Application for Works Approval Amendment

Works Approval Number	W6772/2023/1
Works Approval Holder	Chevron Australia Pty Ltd
ACN	086 197 757
File Number	DER2022/000691
Premises	Gorgon LNG Project Legal description – Part of Crown Lease L077431, Certificate of Title Volume LR3168 Folio 315, Site 1 on Deposited Plan 409277; Part of Crown Lease L077428, Certificate of Title LR3158 Folio 476, Site 5 on Deposited Plan 64220; Temporary Wastewater Injection Facilities Licence LIC00554/2009_1_43; Part of Revised Service Corridor Easement L641372, Certificate of Title Volume LR3142 Folio 58, Deposited Plan 91514 and; Onshore Feed Gas Pipeline Right of Way Easement L466759, Certificate of Title Volume LR3142 Folio 58, Deposited Plan 91514.
Date of Report	25 November 2025
Proposed Decision	Revised works approval granted

Figure 1: Proposed additional areas for crushing and screening activities, to be incorporated into the prescribed premises boundary.

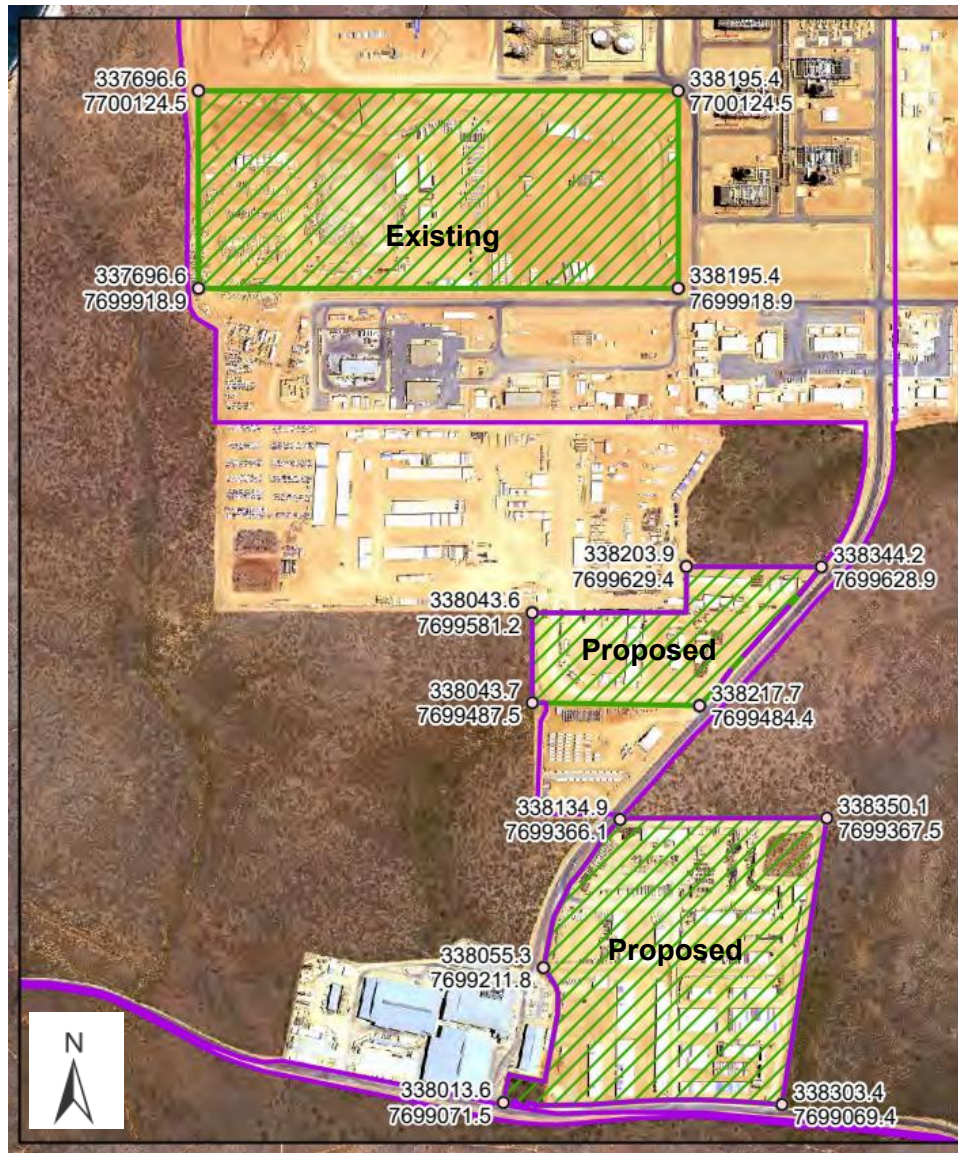
Chevron also proposes to expand approved crushing areas to include two additional sites south of the gas treatment plant, with the prescribed premises boundary amended to incorporate these areas accordingly. These new areas are shown in Figure 1 as green shaded sections labelled “Proposed”.

Additionally, the delegated officer has amended the premises boundary to include the two proposed areas where the crushing and screening plants can operate.
